STATE OF OHIO DEPARTMENT OF TRANSPORTATION

RESURFACING 0.6 MILES OF QUIGLEY RD. FROM CLARK AVE. TO W. 3RD ST. AND 1.2 MILES OF W. 3RD ST. FROM QUIGLEY RD. TO CENTRAL AVE. IN THE CITY OF CLEVELAND. THIS PROJECT ALSO INCLUDES PAVEMENT BASE REPAIRS, CASTING ADJUSTMENTS, ADA COMPLIANT CURB RAMPS, AND NEW PAVEMENT MARKINGS AND SIGNAGE.

CITY OF CLEVELAND CUYAHOGA COUNTY FINAL TRACINGS

ADDENDUM DESCRIPTION NO. DATE REVISED END PROJECT STATION 03/18/24 REVISED LENGTH/LIMITS OF PROJECT ON W. 03/18/24 3RD ST. REVISED DATE FOR SUPPLEMENTAL 03/18/24 SPECIFICATION 832

£ CONST. W 3RD ST. WORK ZONE — SEE NOTE 1 WORK ZONE CENTER LINE, CLASS I 3RD STREET - PHASE 3A CANAL RD. TO CENTRAL AVE. WORK ZONE EDGE LINE, CLASS I (WHITE) -_____

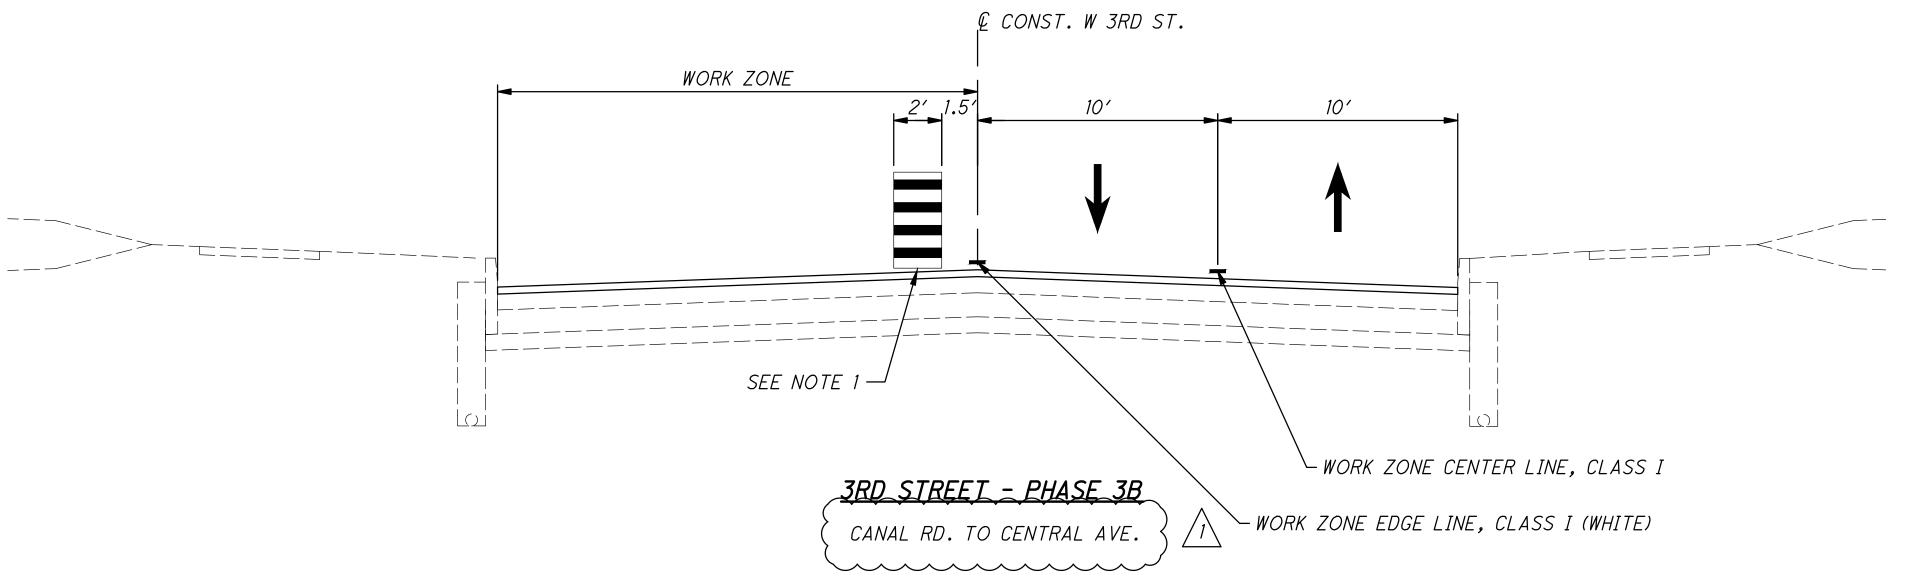
ADDENDUM
NO.	DATE	DESCRIPTION
1	03/25/24	PROJECT LIMITS REVISED
